REGULATORY INFORMATION DISTRIBUTION SYSTEM (RIDS)

SUBJECT: Forwards application for Amend 88 to License NPF-22, adding containment isolation valves to Table 3.6.3-1.

SUSQUEHANNA STEAM ELECTRIC STATION
PROPOSED AMENDMENT NO. 88 TO
LICENSE NO. NPF-22: ADDITION OF
NEW CRM SAMPLE LINES
PLA-3447 FILES A17-2/R41-2

Docket No. 50-388

FIGURE 1

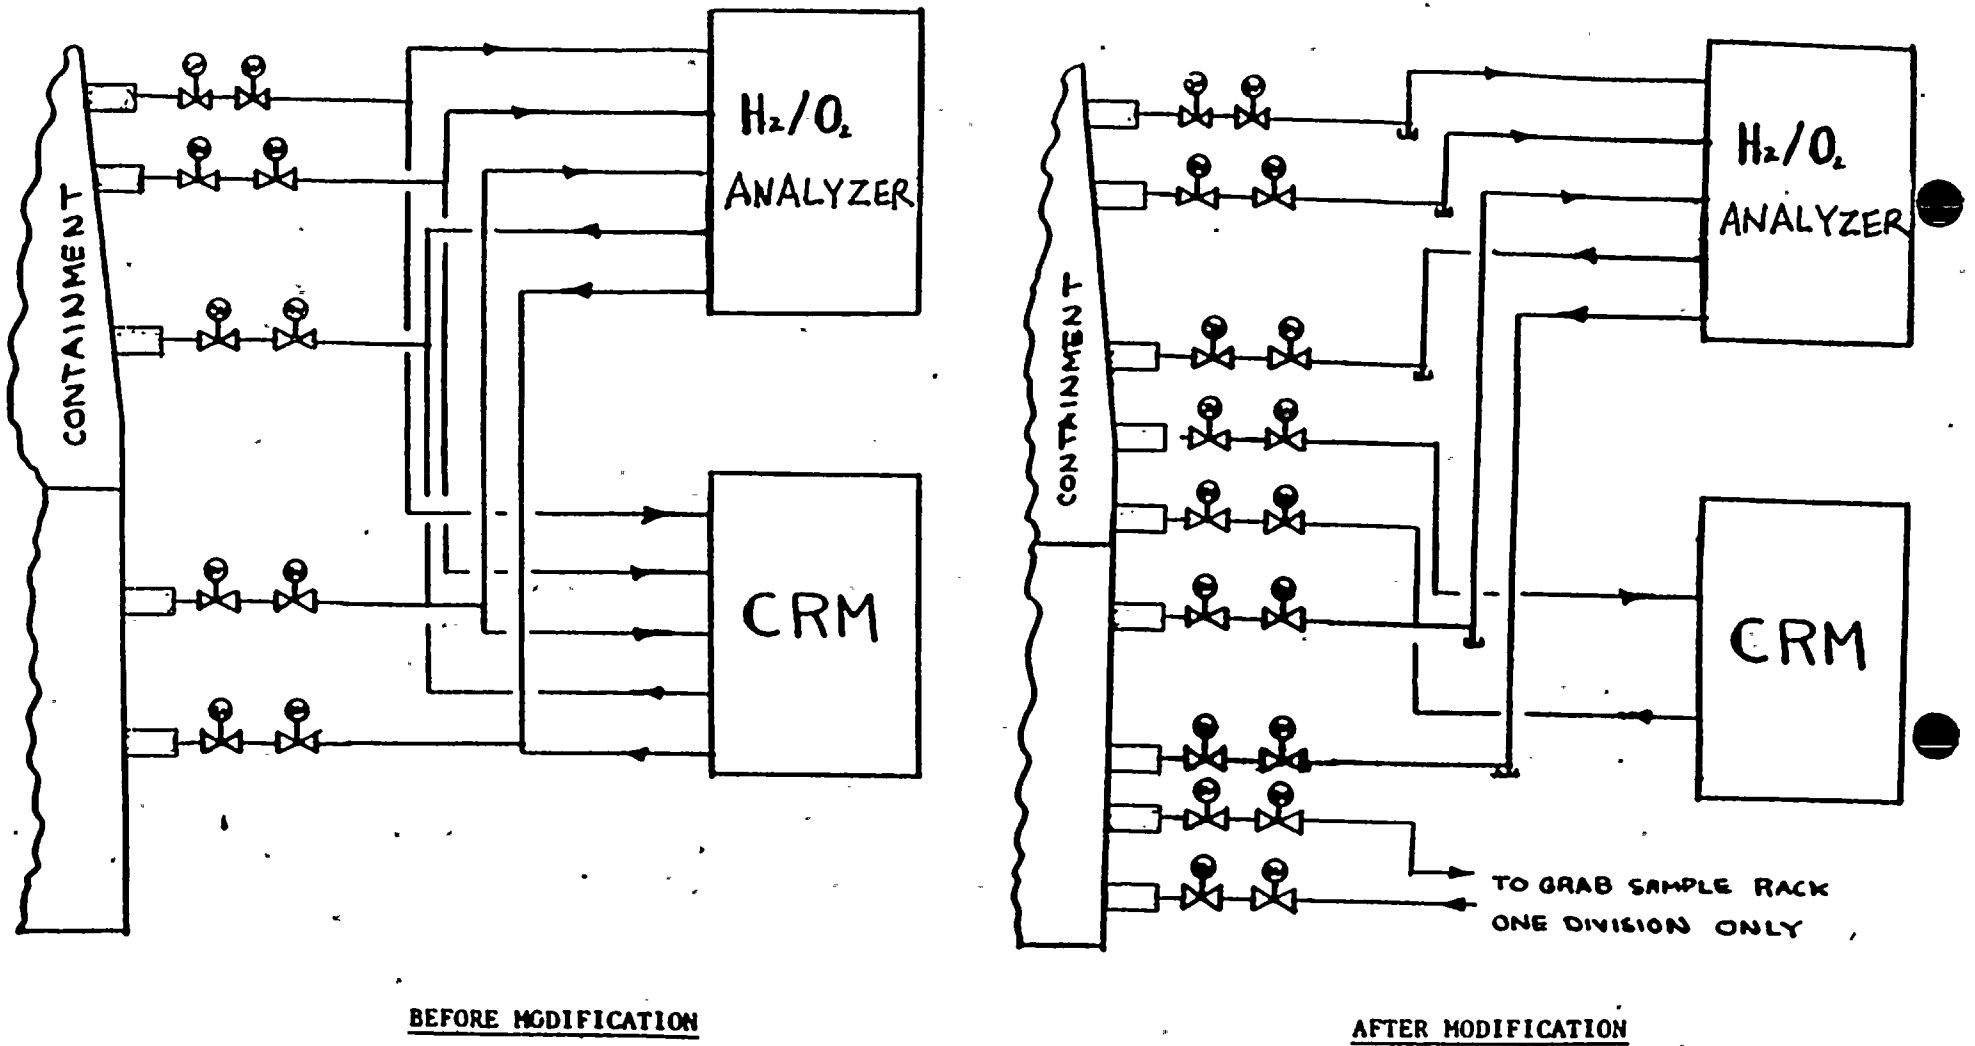
The existing CRM panels share sample lines with the H2/O2 analyzers and the PASS system (see Figure 1). These latter two systems are required to be available post accident, and therefore the CRM panels have been subjected to meeting containment leakage criteria in a post accident environment. Ensuring leak tightness of the sample pumps has resulted in persistent operational and maintenance problems. A modification is therefore proposed that separates the CRM panels from the post accident systems by giving them dedicated sample lines with redundant containment isolation valves (see Figure 1).

This modification is the first in a series of modifications that will replace the existing CRM system, and will be performed in the upcoming Unit 2 fourth refueling and inspection outage. New CRM panels are scheduled to be added to the system later, and in the interim, the old panels in the existing configuration (Figure 1) will be relied upon to supply CRM data. The new sample lines,

The existing CRM panels share sample lines with the H₂/O₂ analyzers. Two new CRM panels and a wetwell sample rack will be installed by future modifications. These new panels and rack will have their own dedicated sample lines with redundant containment isolation valves which will be designed to close on process signals which will be provided in a future modification.

Two sample lines will be routed inside containment to obtain atmosphere samples. Each of the new CRM panels (to be installed later) will draw a sample from its own line, which will be 1" HCB class piping. Each CRM panel will have a sample return line to the containment of the same pipe size and class as the sample piping. Each sample and return line will have two containment isolation valves installed outboard of the containment penetration. The valves will be 1" Class 1E process solenoid valves arranged in conformance with detail "q" of Figure 6.2-44g of the FSAR.
